**PLANNING PROPOSAL
2-32 JUNCTION STREET, FOREST LODGE**

I refer to your correspondence on 16 April 2015 regarding the Planning Proposal submitted for the above address. The purpose of this letter is to provide additional information and to respond to a number of concerns raised by Council. These are addressed individually as follows:

Figure 1 – Building A and Building B separation diagram

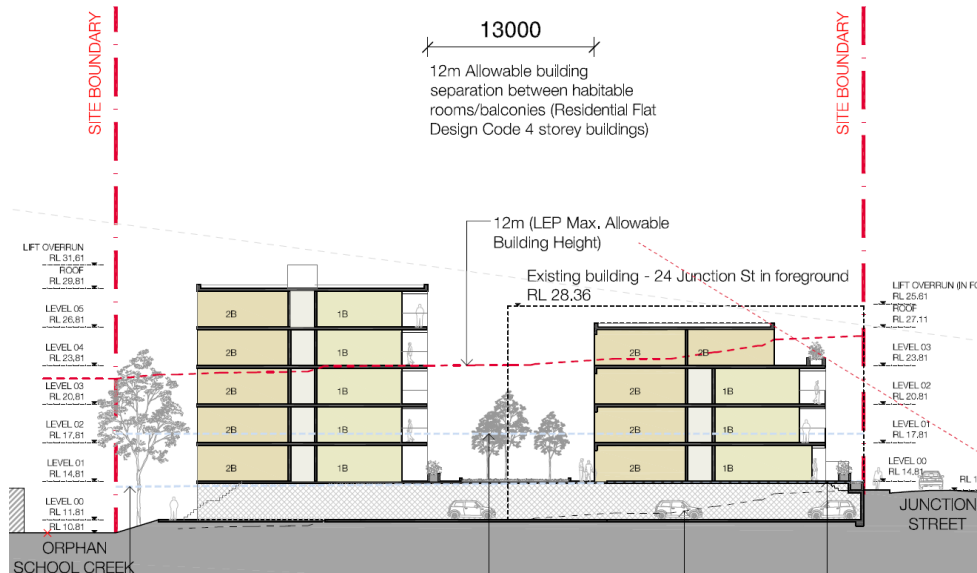
5. Building separation

The proposal has been designed to accommodate two separate building blocks in the north-western section of the site, known as Buildings A and B. These buildings are located at a podium level above natural ground, due to the requirement of an open basement level. This podium covers virtually the entire site and substitutes natural ground level due to flooding constraints (discussed above).

To this end, a minimum separation of 12m is required from Levels 1 to 4 under the RFDC. The proposal exceeds this 12m minimum by 1m as shown below at **Figure 1** and **Appendix C**. Level 5 of Building A does not directly overlook any other residential levels within the site and as such, no building separation issues arise.

Figure 2 – Typical section of the Junction Street footpath interface

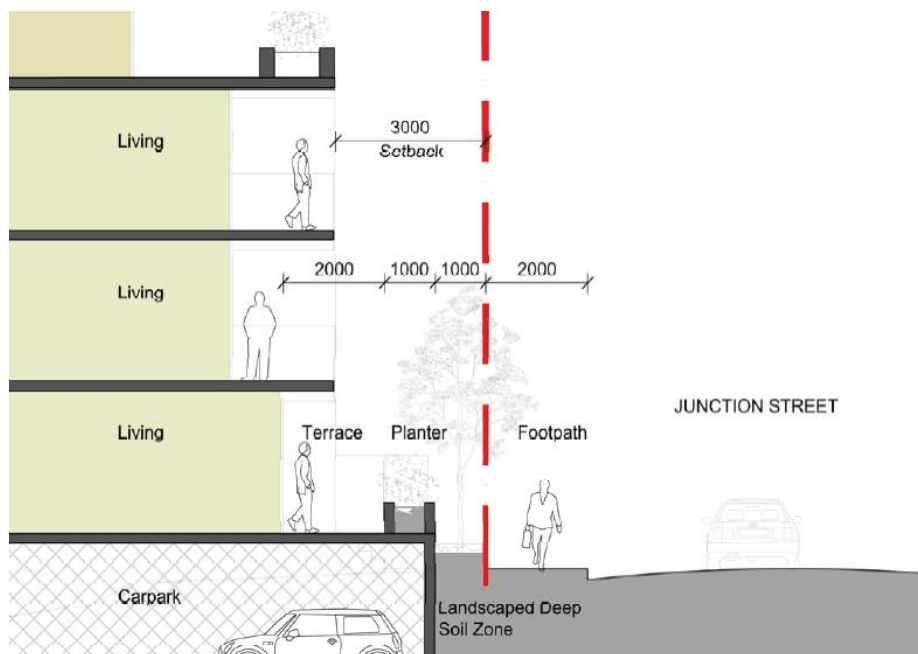
11. Footpath widening

With regard to the need to physically widen the Junction Street footpath, we note that pedestrian traffic along Junction Street is low and is expected to remain at a low level following redevelopment of the site. The existing non-residential building at the centre of the site is also located hard up against the existing boundary with a nil setback. Any widening of the footpath would therefore result in this building standing out and interrupting the footpath line, which is considered undesirable from both an urban design and functionality point of view.

The existing footpath on Junction Street along the site's frontage is approximately 2m wide. The Indicative Master Plan that accompanies the Planning Proposal provides a 1m landscaped buffer along its frontage that will act as a visual extension of the footpath and provide means to support landscaping, including street tree plantings.

The design of this landscaped strip is intended to be graded to step up to the terrace planter boxes of the indicative building envelopes. This will stagger the rise of the development from Junction Street, and will ensure an appropriate visual relationship to Junction Street together with an improved pedestrian relationship with the street when compared to the existing situation (refer to **Figure 2** below and **Appendix F**).
